UNITED STATES PATENT AND TRADEMARK OFFICE

APPLICATION NO.	FILING DATE	FIRST NAMED INVENTOR	ATTORNEY DOCKET NO.	CONFIRMATION NO.
09/720,762	12/28/2000	Kazuyuki Yanase	114474-14-FESI00002US	5214
38492	7590	05/04/2005	EXAMINER	
WILLKIE FARR & GALLAGHER LLP INTELLECTUAL PROPERTY LEGAL ASSISTANTS 787 SEVENTH AVE NEW YORK, NY 10019-6099			SAYOC, EMMANUEL	
			ART UNIT	PAPER NUMBER
			3746

Office Action Summary	Application No. 09/720,762	Applicant(s) YANASE ET AL.	
	Examiner Emmanuel Sayoc	Art Unit 3746

DETAILED ACTION

Examiner's marked Figure
Please Include in Office Action

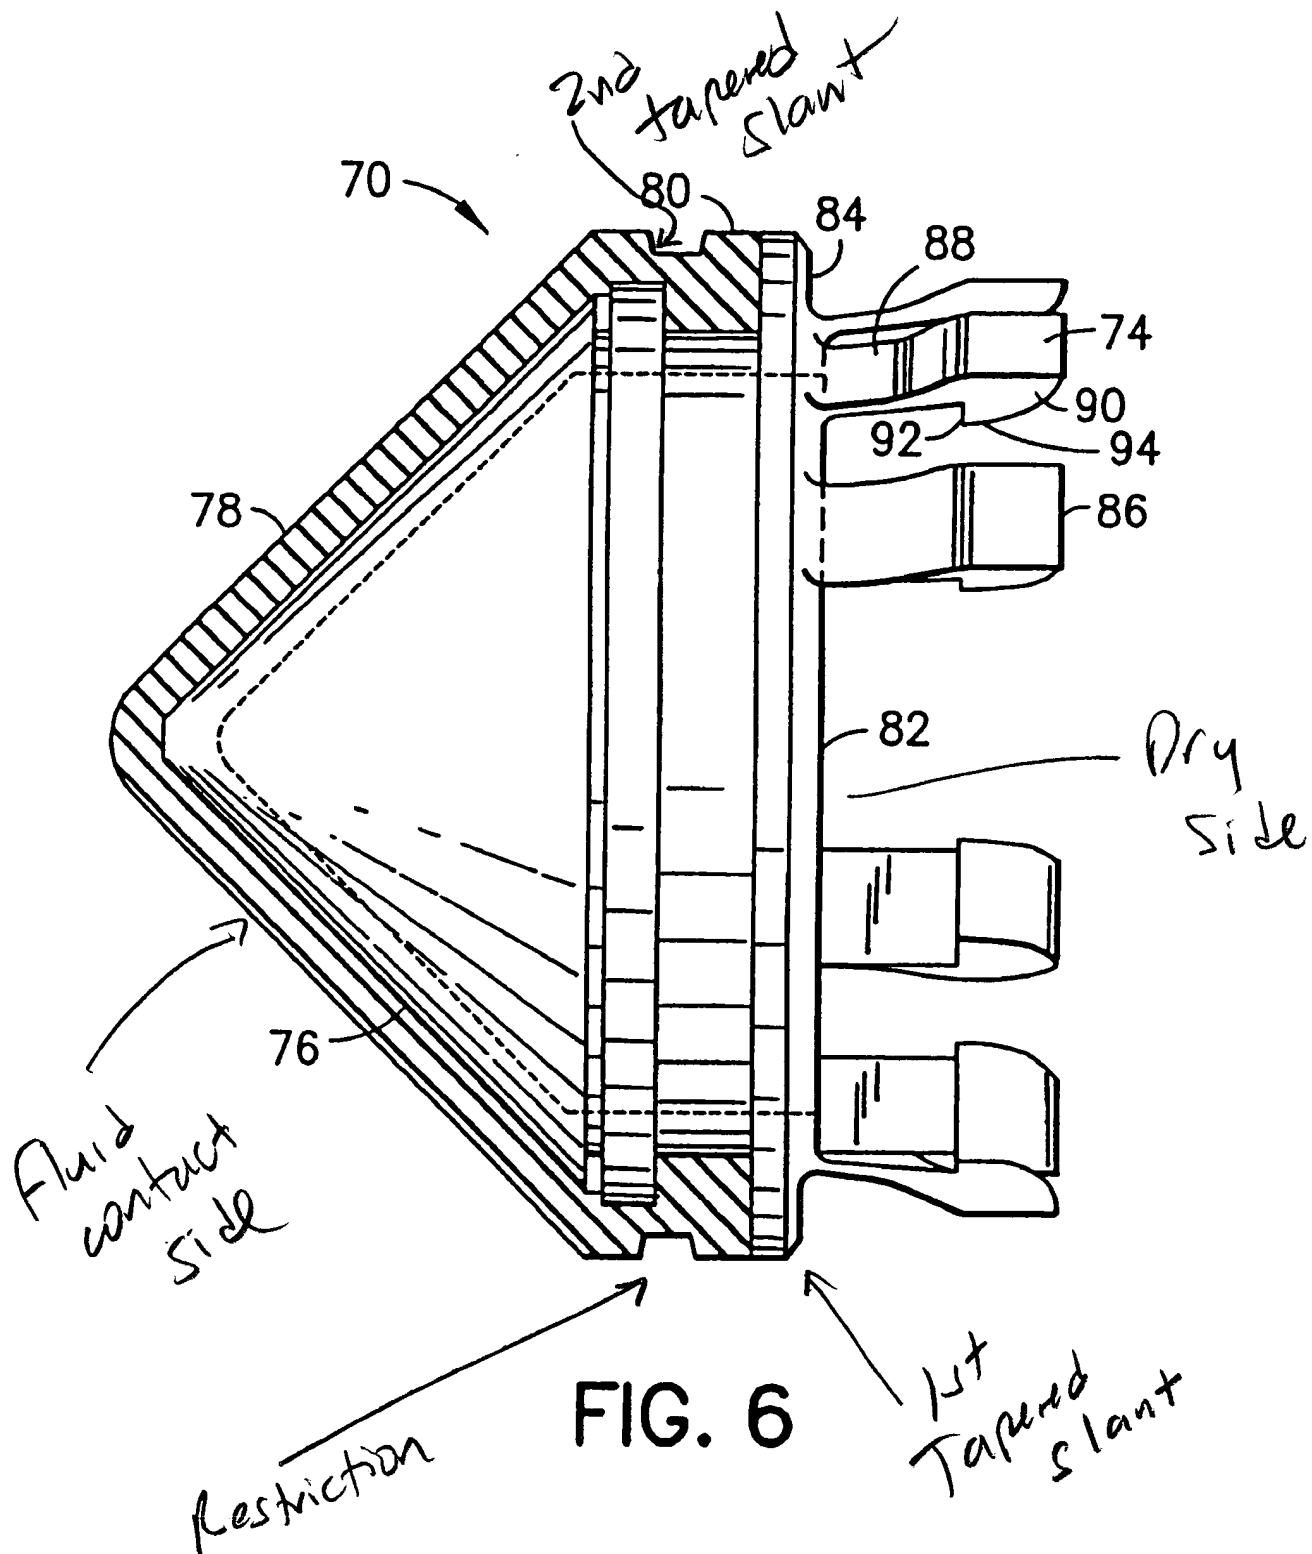
With respect to claims 1, and 3, Trull et al., in Figure 6, disclose a syringe gasket (70) wherein a peripheral side surface (80) of the gasket is in contact with an inner surface of the syringe barrel (60). A restriction (labeled by the examiner on Figure 6 attached to the end of this office action) is provided, and a periphery of a bottom surface

of the gasket that is not in contact with the liquid is formed into a tapered slant (also labeled by the examiner on Figure 6).

With respect to claim 3, the Trull et al. apparatus comprises a tapered slant with a first and second plunger diameter. The examiner has labeled these embodiments on the marked up Figure 6.

With respect to claims 9 and 10, a second tapered (see examiner's marked up Figure 6) slant is formed between the peripheral side surface of the gasket (70) that is in contact with an inner surface of the syringe barrel (60) and the restriction (see examiner's marked up Figure 6). The gasket tightly closing the liquid is an obvious requirement for the syringe to pump fluid properly. A recitation with respect to the material intended to be worked upon by a claimed apparatus, in this case a contrast medium, does not impose any structural limitations upon the claimed apparatus, which differentiates it from the prior art apparatus satisfying the structural limitations of the claims, as is the case here.
